#### **ADDENDUM NO. ONE (1)**

#### PERIMETER FENCE

Wayne Executive Jetport Wayne County, North Carolina

WKD Project Number 20240064.00.WK February 14, 2024

TYPICAL F-163-1 WILDLIFE DETERRENT FENCE SKIRT DETAIL

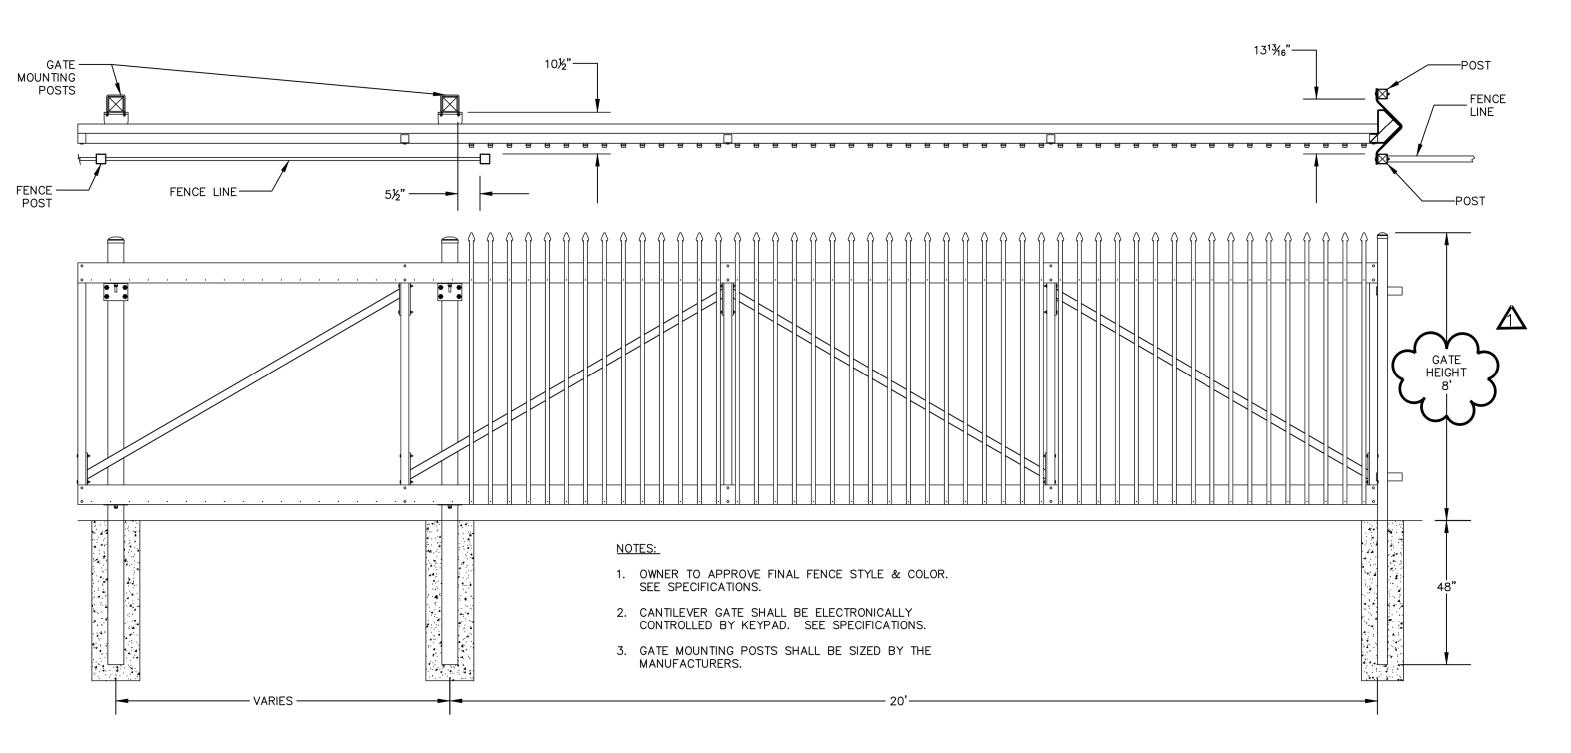
1. **Question:** Looking at these plans, they are asking for the ornamental to be 9' but the tallest Ameristar has is 8'. I wanted to confirm that it was the 8' that you guys were looking for.

Plan Sheets 09 and 10 have been revised to change the ornamental fence and gate heights from 9-feet to 8-feet.

**Answer:** That is correct. The ornamental fence should have a height of 8-feet. The ornamental fence details have been corrected on the attached detail plan sheets.
